File 1990-0027

Name Taco Bell - C-1 & RSF-8 to PB

**REVIEW SHEET SUMMARY**

#27-90 REZONE / TACO BELL (Page 1 of 3)

# DRAIN TROUGH FOR SIDEWALK CROSSING

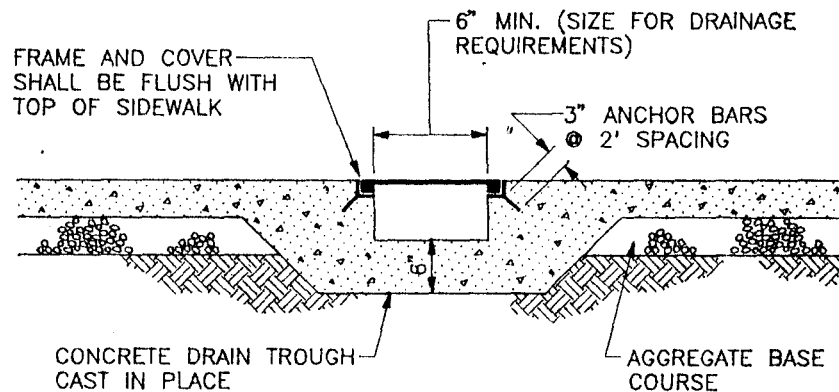
All drainage troughs constructed in the public right-of-way shall be in accordance with City Standard Drawing ST-2.

1) The sidewalk crossing drain on Glenwood Avenue does not meet City standards and must be replaced. (See copy of ST-2 drawing enclosed.)

- 10) ALL DRAINAGE TROUGHS WILL BE CONSTRUCTED IN ACCORDANCE WITH CITY STANDARD DRAWING ST-2. SEE SITE PLAN INSERT.
- 11) ALL UNUSED CURB CUTS ON NORTH AVE. AND GLENWOOD AVE. WILL BE REMOVED AND REPLACED WITH CURB, GUTTER, AND SIDEWALK TO MATCH EXISTING.

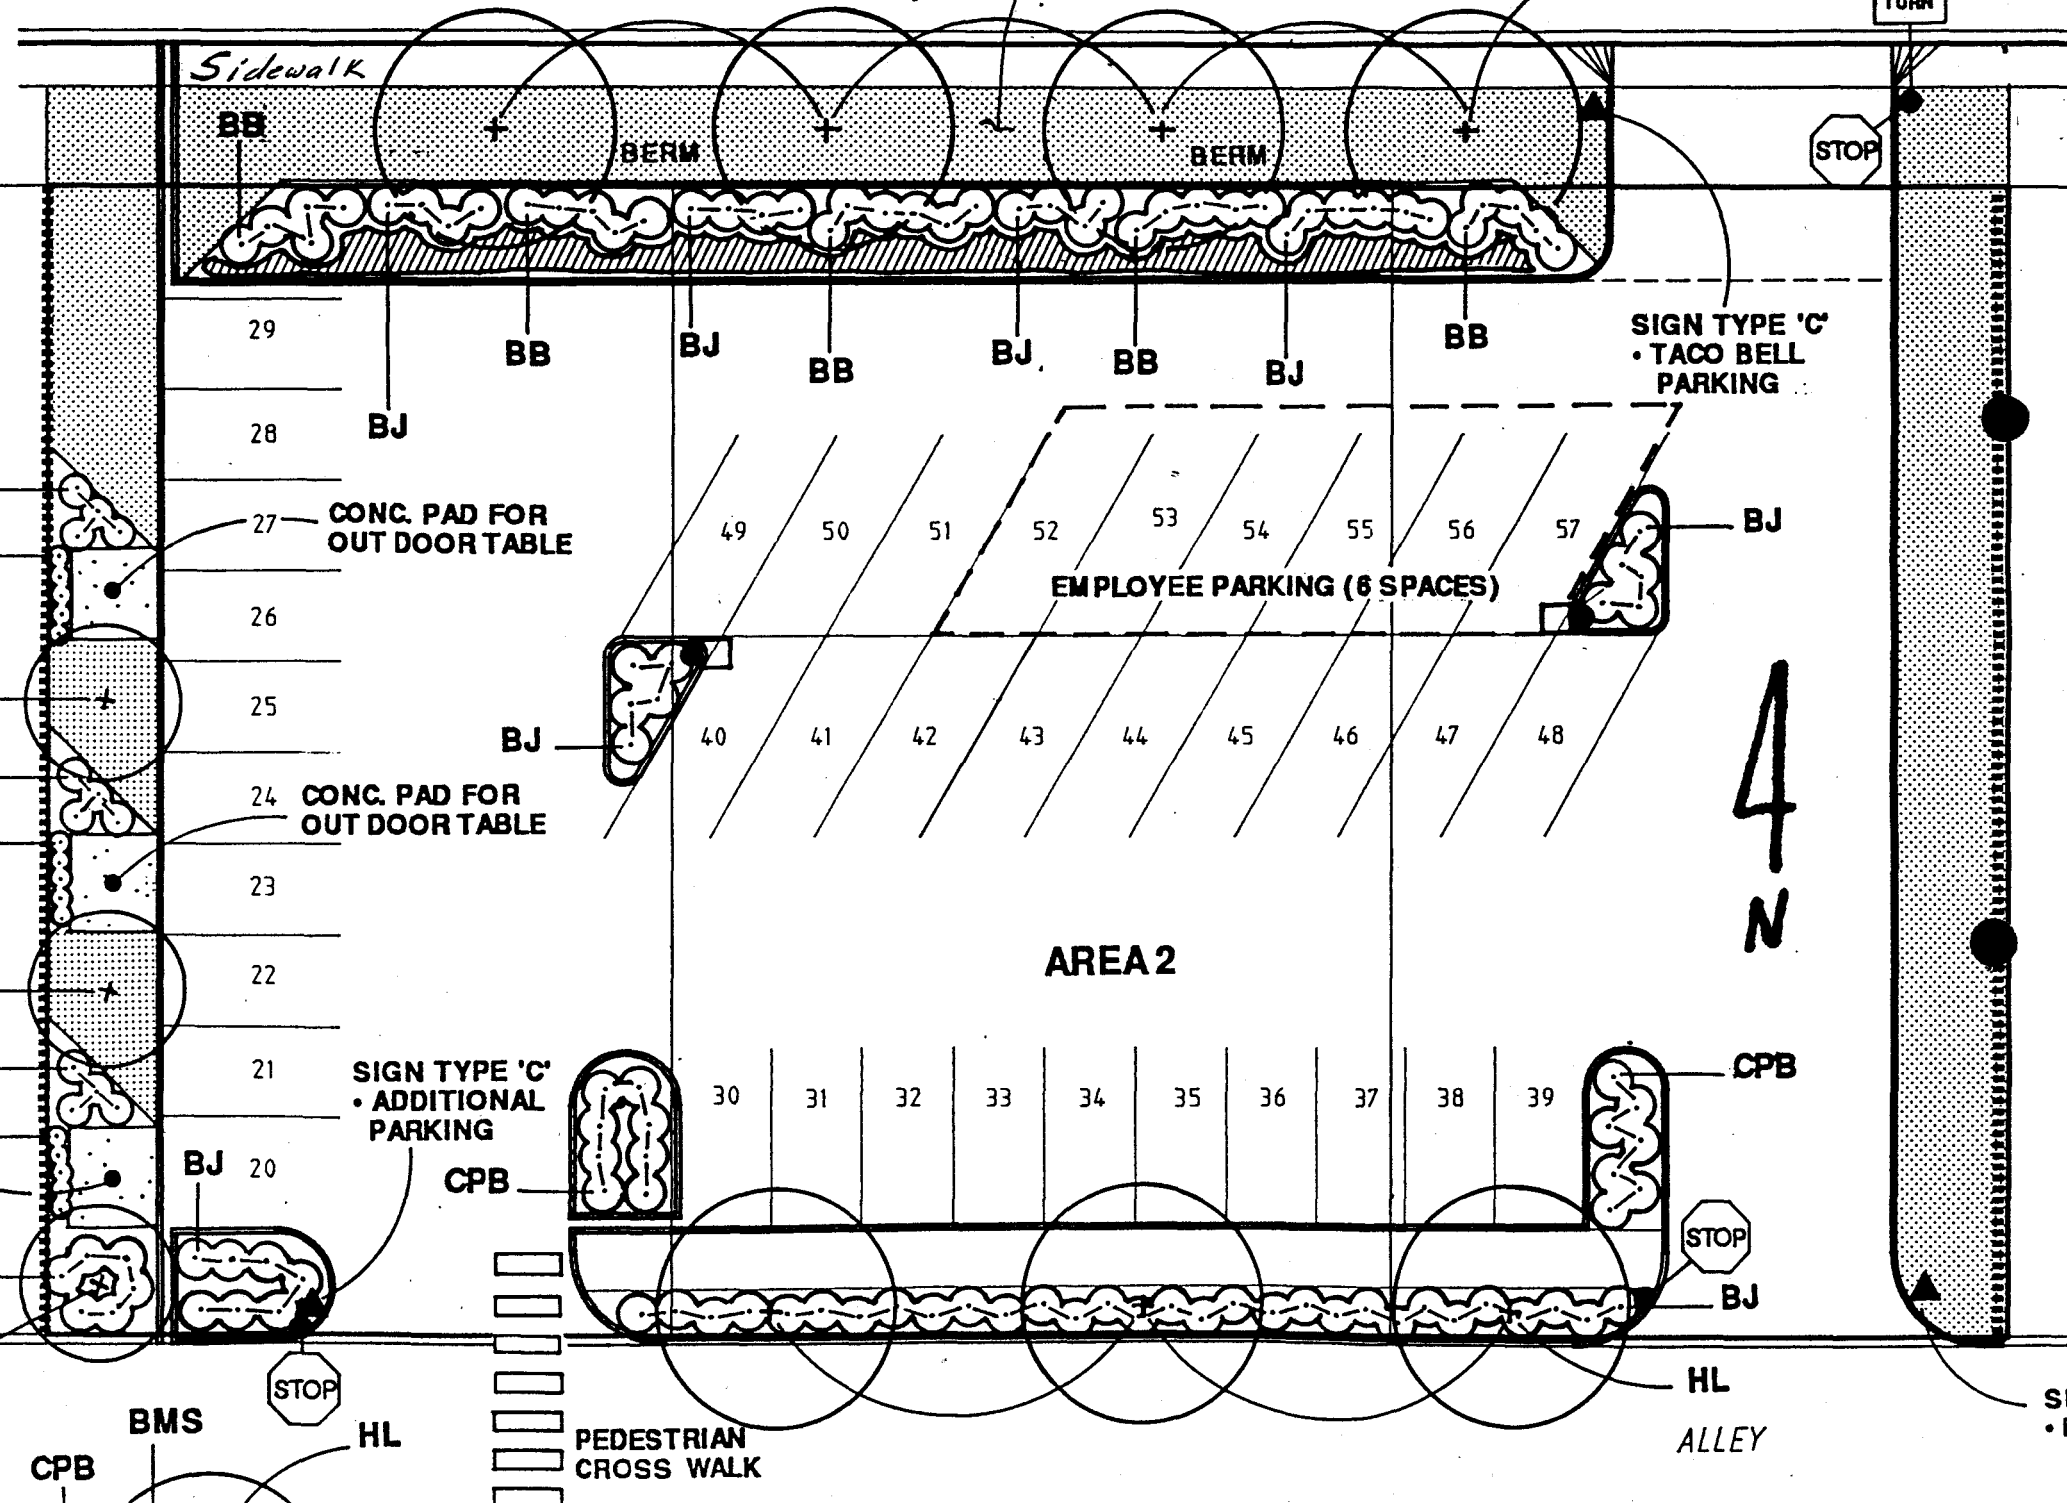
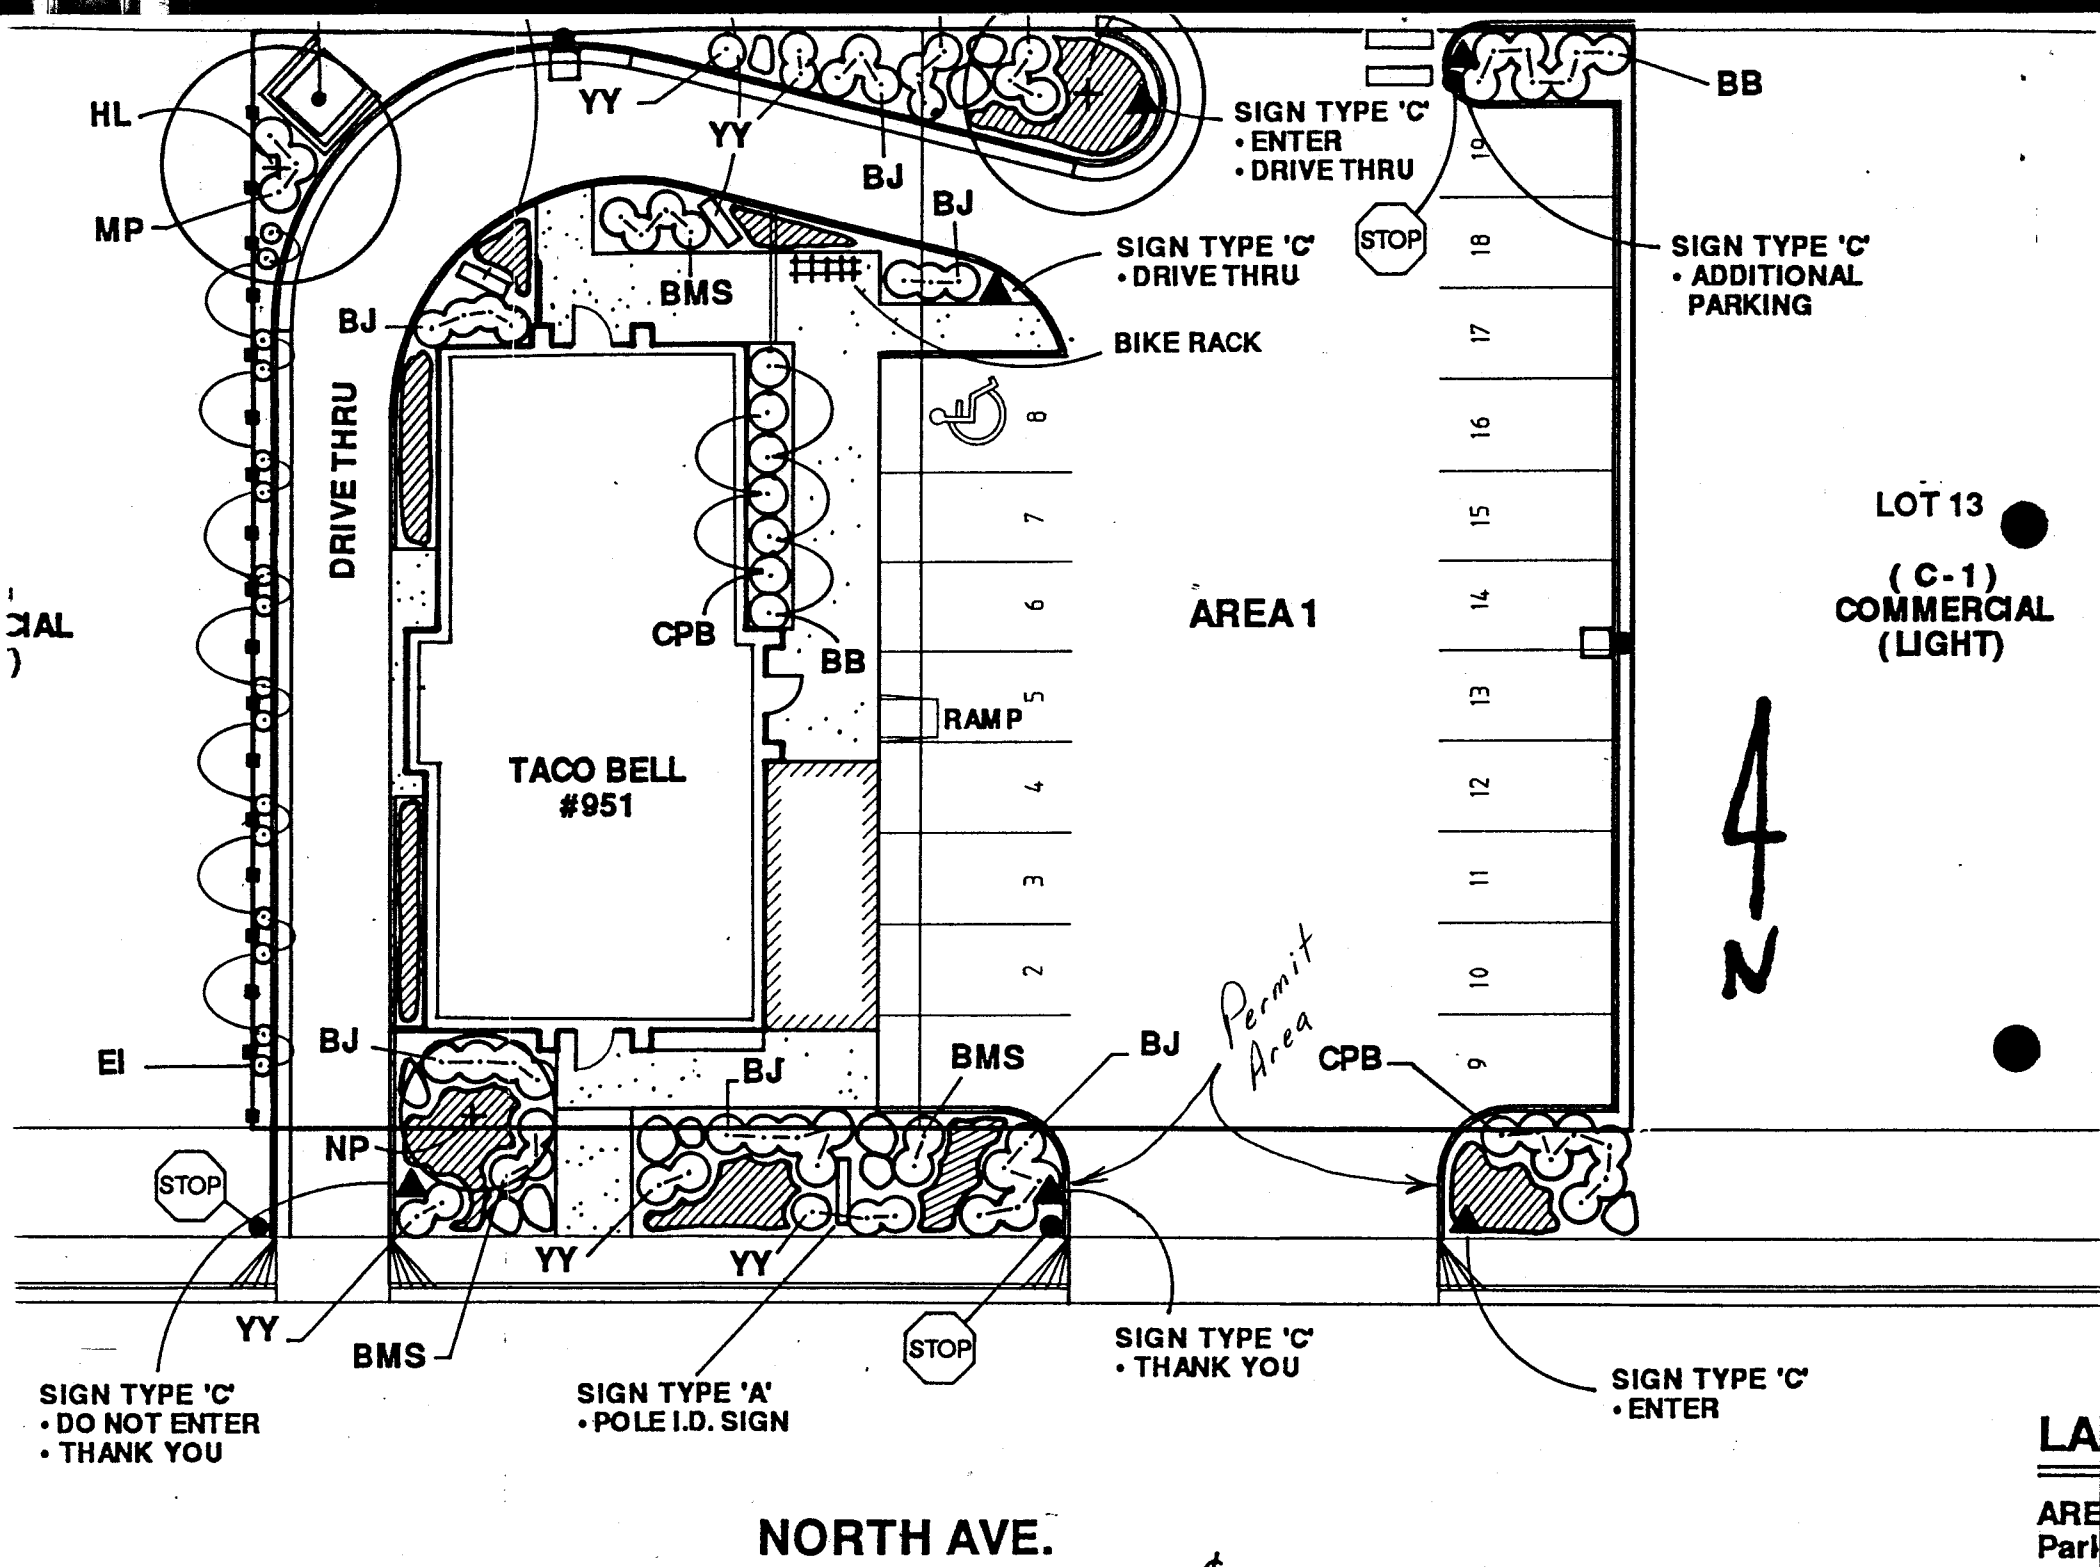
Each handicap parking space and unloading area should be 17' wide. Unloading area and curb ramps should be on the right side of each handicap parking space.

Curbing along east side of the building lot should allow for 2' vehicle overhang between face of curb and property line. Only 1' is provided on site plan.

The type and location of all traffic control signs should be shown on the site plan. Stop signs will be required at all exits onto North Avenue, the alley and Glenwood Avenue.

In the north parking lot, I would like to see the space between the west property line and the proposed curb increased to 10'. This would allow better alignment of the driveways crossing the alley and would provide enough width for landscaping in the space between the curb and property line. This could be done by removing three parking spaces from the center of the lot.

We need to see a plan showing parking lot lighting coverage and the type of light fixture proposed. What is the proposed screen wall/fence? Show detail on plan.

Need more detail on screening/fencing. The code requires the screening to be 6' whether it is a solid fence or solid year-round landscaping. Need to know height, type of construction, etc.

Need more signage detail on plan - re: type, size, and location.

Need more information on parking lot lighting. Needs to be low impact lighting. Lighting facilities must be directed away from residential property and the vision of passing motorists. Need to know type and location of lighting on site plan.

- 1) THE SITE PLAN HAS BEEN AMENDED TO SHOW THE CORRECT DIMENSIONS FOR THE HANDICAP PARKING SPACE.
- 2) THE SITE PLAN HAS BEEN CHANGED TO REFLECT 2' ALONG THE EAST SIDE OF BUILDING PARKING LOT.

- 3) THE SITE PLAN NOW SHOWS ALL TRAFFIC CONTROL SIGNS.
- 4) WE ARE AWARE OF YOUR CONCERN FOR THE STACKING IN THE DRIVE-THRU LANE. WE FEEL FROM PAST EXPERIENCE IT WILL NOT POSE A PROBLEM. OUR GOAL IS TO HANDLE EACH AUTO IN THE DRIVE-THRU IN APPROX. 45 SECONDS PER CAR.

- 5) CURB RADII HAVE BEEN CHANGED INCREASED WHERE POSSIBLE TO 10'.  
(SEE REVISED SITE PLAN)
- 6) THE SPACE IN THE NORTH PARKING LOT HAS BEEN INCREASED TO 12'. THE DRIVEWAYS CROSSING THE ALLEY HAVE BEEN ALIGNED.  
(SEE REVISED SITE PLAN)

- 7) WE HAVE HAD A ENGINEER SHOW THE CORRECT LIGHTING FIXTURES. THE LIGHTING FACILITIES WILL BE DIRECTED AWAY FROM RESIDENTIAL. SEE DIAGRAM ON SITE PLAN FOR TYPE OF FENCING.

- 8) SEE SITE PLAN ATTACHMENT FOR SIGNAGE DETAIL.
- 9) ALL LANDSCAPING WITHIN 5' OF PUBLIC SIDEWALK AND 10' OF THE ALLEY WILL BE UNDER 30 INCHES IN HEIGHT.  
(SEE REVISED LANDSCAPE PLAN).

- 12) THE SIDEWALK ON THE SOUTH SIDE OF NORTH PARKING LOT HAS BEEN DESIGNED TO BE 6' WIDE TO ALLOW FOR VEHICLE OVERHANG.  
(SEE REVISED SITE PLAN)
- 13) THERE WILL BE A DESIGNATED CROSSWALK FOR PEDESTRIANS TO CROSS ALLEY  
(SEE REVISED SITE PLAN).

- 1) THE SCREENING/FENCING WILL BE 6' HIGH. SEE SITE PLAN INSERT FOR FENCING DIAGRAM.
- 2) MORE SIGNAGE DETAIL HAS BEEN ADDED TO SITE PLAN.  
(SEE REVISED SITE PLAN)
- 3) WE HAVE HAD ENGINEER DESIGN PARKING LOT LIGHTING. LIGHT WILL BE DIRECTED AWAY FROM RESIDENTIAL PROPERTIES. (SEE ATTACHMENT TO SITE PLAN).
- 4) THE WEST DRIVEWAY ALONG GLENWOOD HAS BEEN ELIMINATED. WE NOW HAVE ONLY ONE EXIT/ENTRANCE ON TO GLENWOOD. NOTE THE EXIT ALLOWS FOR RIGHT TURN ONLY. (SEE REVISED SITE PLAN).
- 5) THE BERM ALONG GLENWOOD HAS BEEN WIDENED TO APPROX 20". THE BERM PLUS LANDSCAPE HEDGE WILL BE 5' TO 6' HIGH. (SEE REVISED LANDSCAPE PLAN).
